October 10, 2025

PROJECT NAME: FIRESTONE OCALA FREEDOM

PROJECT NUMBER: 2024090064

APPLICATION: MAJOR SITE PLAN #32039

PRODUCT #	224.059	
DATE	04/04/2025	SHEET C1
SCALE	1" = 40'	
SITE PLAN OVERALL

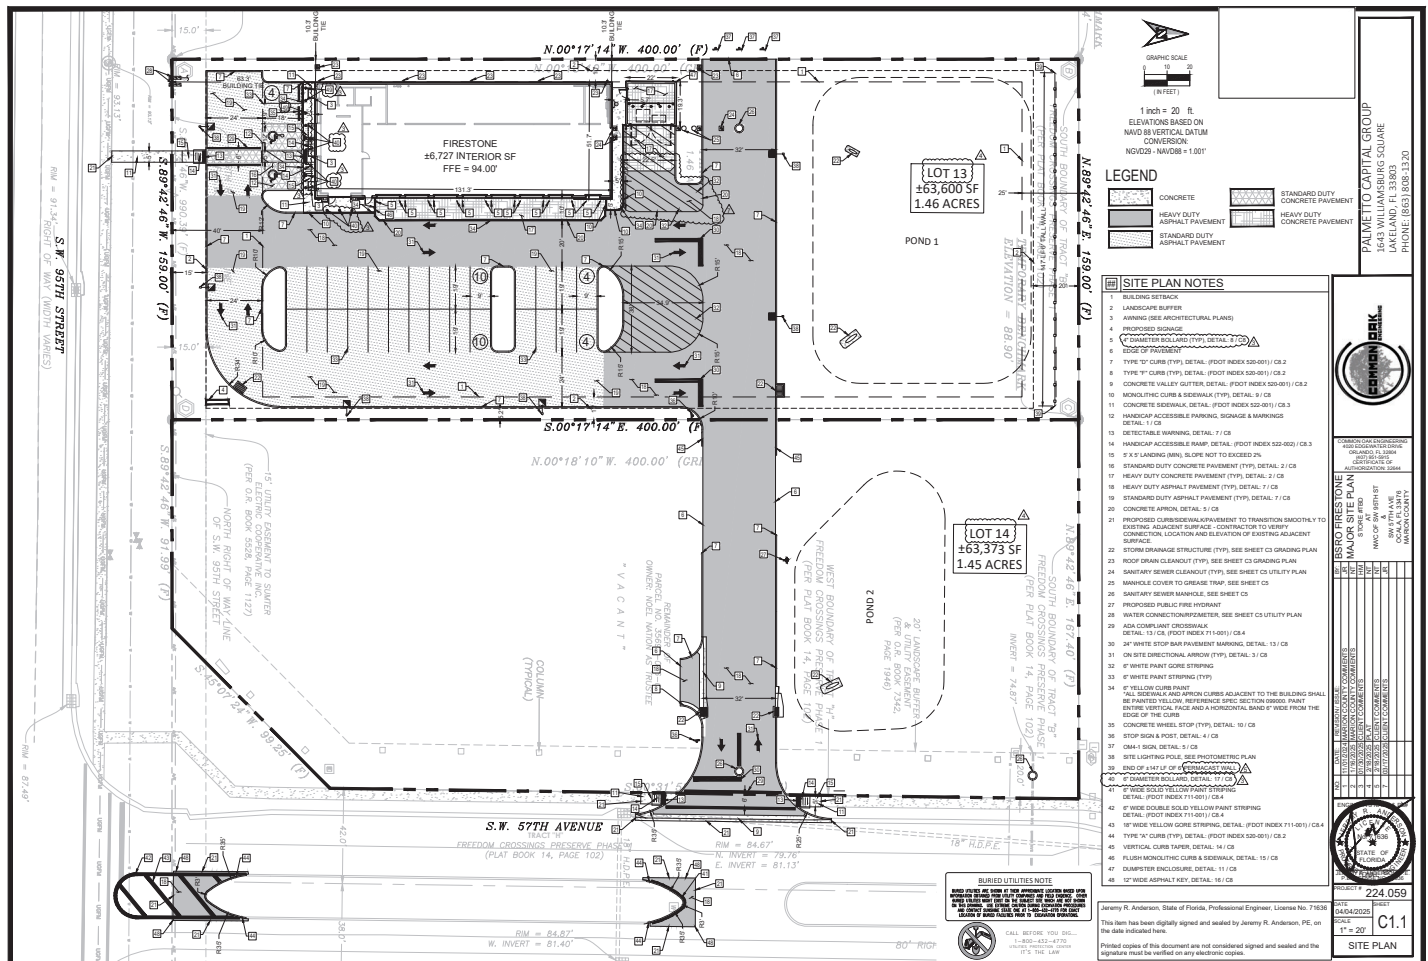
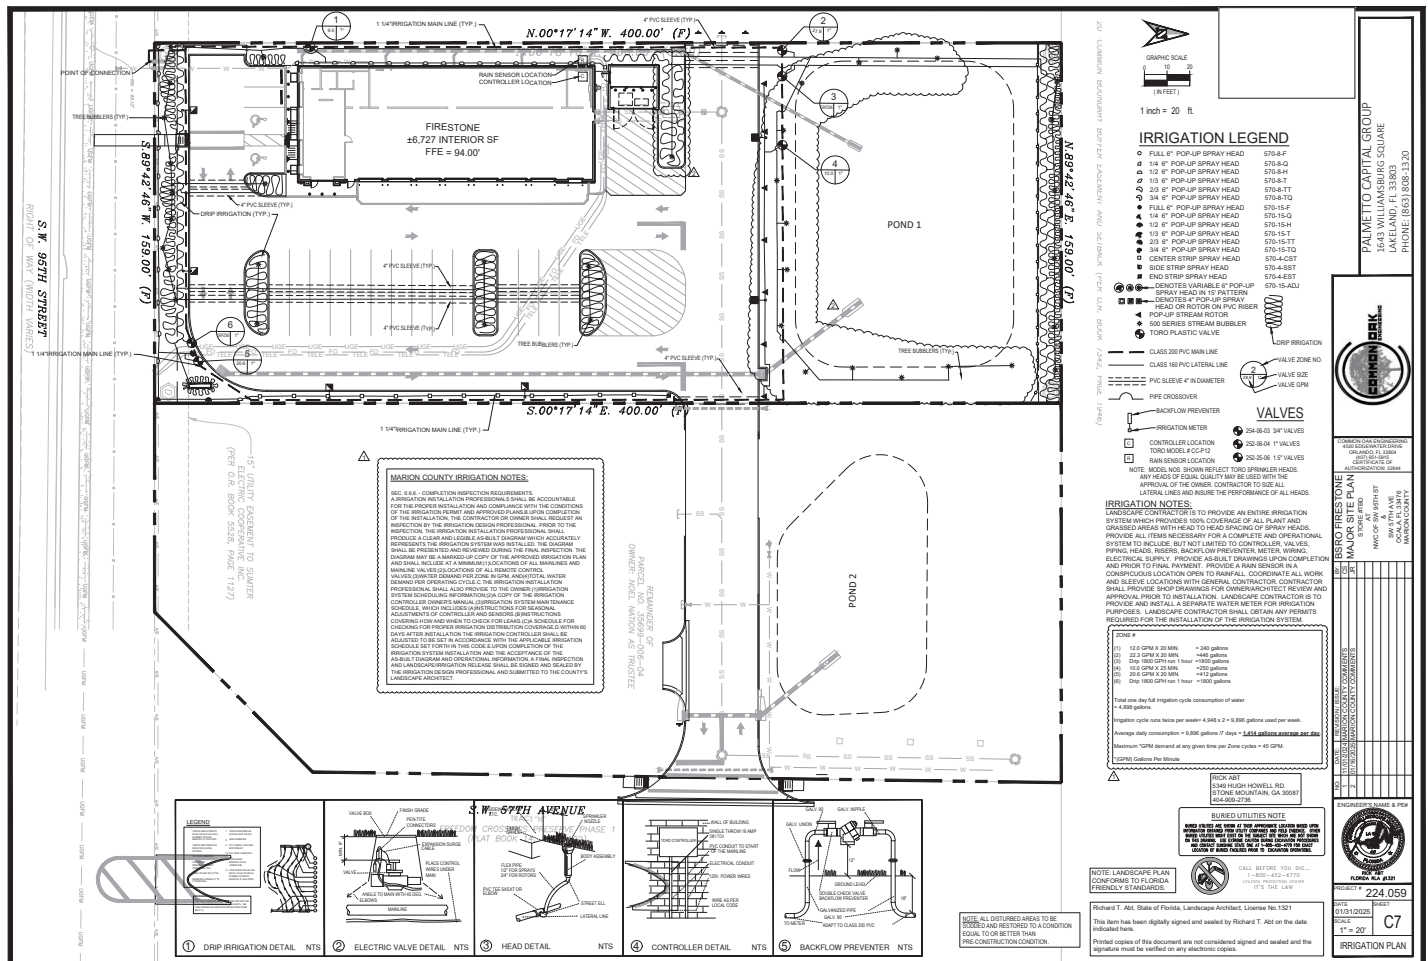
8/1/25 - Following an extensive review, the required public cross-access has not been provided. Reference documents provided indicate flexible terms of access by participants within the development but not by the public. Recommendation is to utilize the County pre-approved cross-access agreement form, exhibiting the implied cross-access represented by the plans and clearly specifying the extent of the cross-access being provided on sheet C1.1.

11/1/24 - A minimum of 24' wide paved public ingress / egress cross-access easement is required parallel to SW 95th Street from property line to property line and must be specified on plans. The heavy-duty pavement area satisfies the pavement requirement. Contact Cheryl Weaver in the Right-of-Way Office at 352-671-8679 to obtain the appropriate template and for recording the easement which must be executed prior to final plan approval.

1. Comment: Applicant submitted customized amendment language that was agreeable to OCE Traffic for legal review, however, a signatory indicated further language may be needed as an alternative to public access. Explained to applicant and signatory that removing public access in favor of alternative language would require DRC approval. Otherwise, the legal review process for the amended language is ready to move forward.
1. Response: **Cross access for this development was handled in the 2020 Development Agreement.**
